CENTRAL AND ROCK ADDITION WICHITA, SEDGWICK COUNTY, KANSAS

RE: SUB 2002-21 -- One-Step Final Plat of Central and Rock Addition

CASE NUMBER: SUB 2002-21 -- CENTRAL AND ROCK ADDITION

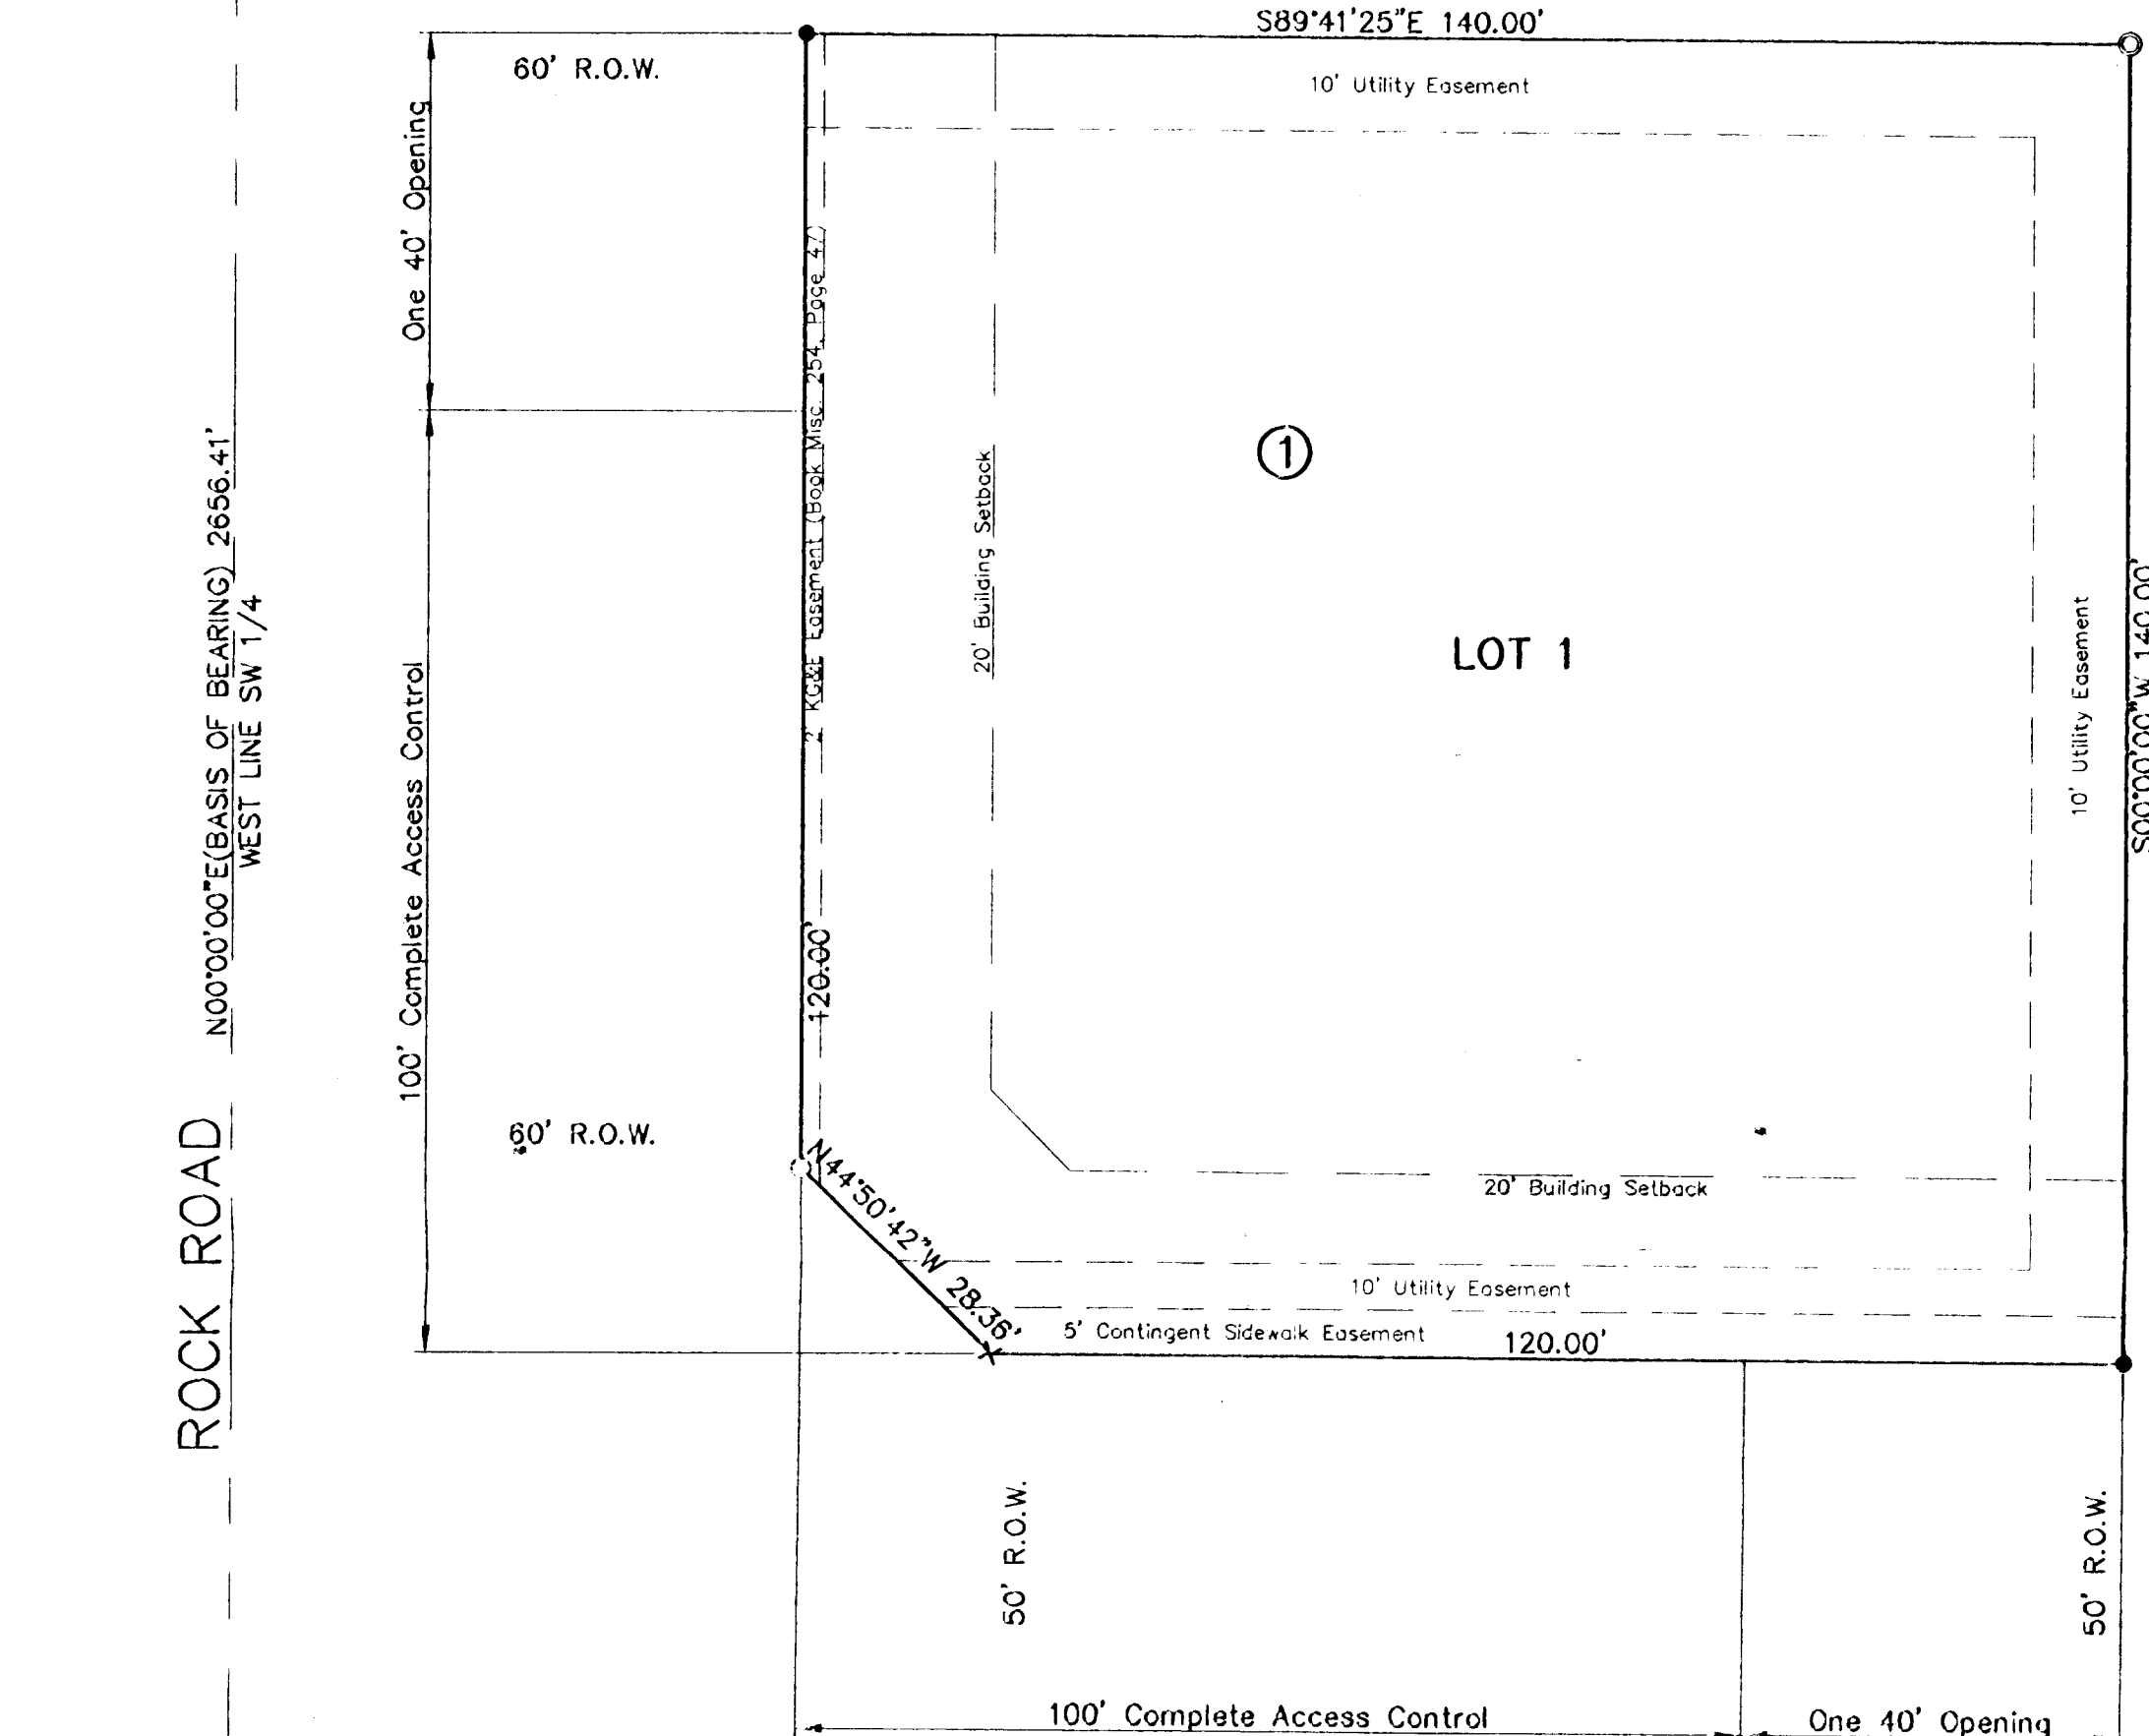
"A 5-foot contingent sidewalk dedication along Central is required, to be located within the required 10-ft utility easement."

- A. Municipal services are available to serve the site. City Engineering needs to comment on the need for guarantees or easements. No guarantees or easements are required.
- B. If improvements are guaranteed by petition, a notarized certificate listing the petitions shall be submitted to the Planning Department for recording.
- C. City Engineering needs to comment on the status of the applicant's drainage plan. The drainage plan is approved.
- D. The plat proposes one access opening along both Central and Rock Road. Distances should be shown for all segments of access control. The proposed access openings have been approved. If a cross-lot access agreement can be obtained with the abutting properties to the east and north, then both driveways shall be closed. Traffic Engineering has requested that the opening along Central be limited to right turns only.

The Subdivision Committee approved full turning movements for the opening along Central.
- E. The applicant has platted a triangular corner clip with a 50-ft right-of-way along Central and a 60-ft right-of-way along Rock Road. Traffic Engineering has requested a 10-ft contingent street dedication.

- F. The applicant shall submit an avigational easement covering all of the subject plat and a restrictive covenant assuring that adequate construction methods will be used to minimize the effects of noise pollution in the habitable structures constructed on subject property.

- G. The owners noted in the platting binder need to be signatories to the plat.
- H. The platator's text shall include language that a drainage plan has been developed for the plat and that all drainage easements, rights-of-way, or reserves shall remain at established grades or as modified with the approval of the applicable City or County Engineer, and unobstructed to allow for the conveyance of stormwater.

- P. The representatives from the utility companies should be prepared to comment on the need for any additional utility easements to be platted on this property. **Southwestern Bell has requested additional easements.**

In lieu of the contingent street dedication, the Subdivision Committee has required a 10-foot utility easement along Central.
